Mobile Pentium® II Processor Specification Update

Release Date: December 1998

Order Number: 243887-005

Figure 2. Workaround Flowchart: SMBALERT#-Driven System

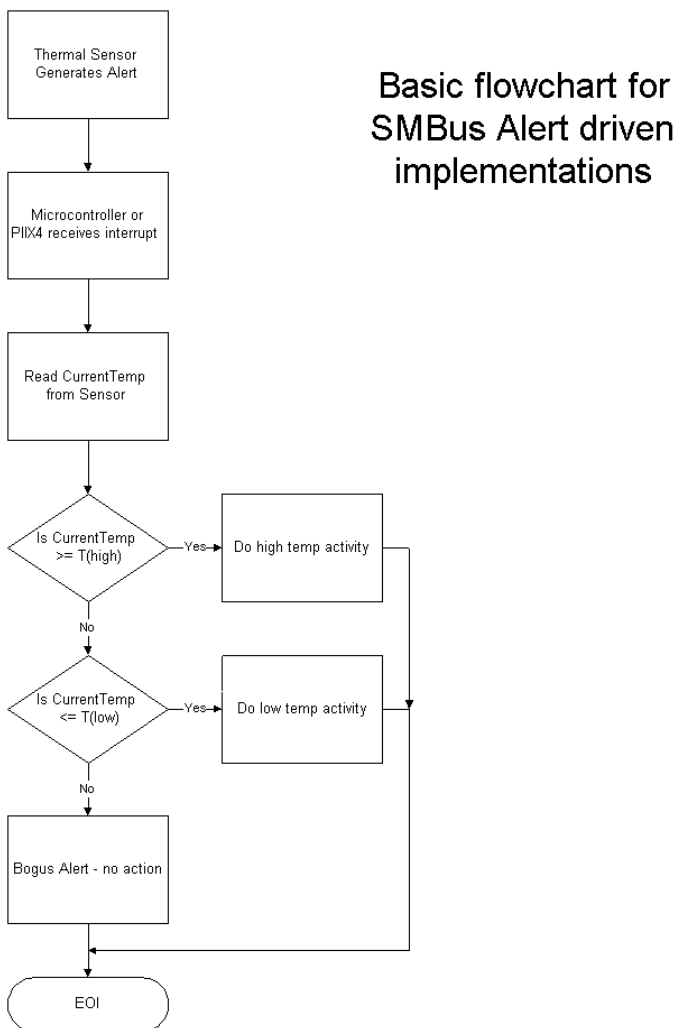
B30. Thermal Sensor May Assert SMBALERT# Incorrectly

Under the conditions described below, the thermal sensor incorrectly generates the SMBALERT# interrupt. *All* of the following conditions must be met to trigger a false interrupt:

WORKAROUND: Three different (mutually exclusive) workarounds are possible:

1. Before servicing an interrupt from the thermal sensor, read and compare the processor thermal reading with the threshold limits (T_{HIGH} or T_{LOW}). Figures 2 and 3 provide basic flowcharts for the implementation of this workaround in an interrupt driven system.
2. If the firmware implemented polls the Status Register only, then before taking any action, re-read the temperature register and do a comparison with the alarm threshold limits (T_{HIGH} or T_{LOW}) to determine if the value is actually still within the temperature window.
3. Use a temperature polling scheme to monitor the processor temperature.

Figure 5.6. Cross Sectional View With Vertical Dimensions

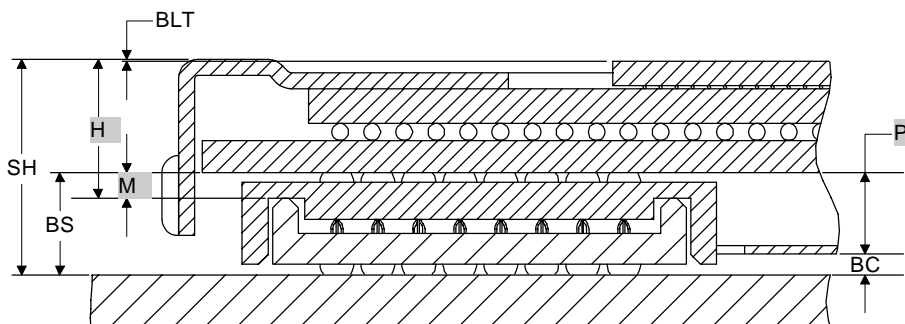
B12. Misabeled Vertical Dimension Parameters

Figure 5.6 in the *Mobile Pentium® II Processor at 233 MHz, 266 MHz, and 300 MHz* datasheet should be replaced by the following figure:

Symbol	Parameter	Min	Nom	Max	Units	Figure
H	Processor Height	4.40	4.55	4.70	mm	5.6
M	Plug Height	0.91	1.03	1.15	mm	5.6
P	Bottom Cover Height	--	2.54	2.81	mm	5.6
BLT	Bond-Line Thickness	0.01	0.12	0.23	mm	5.6
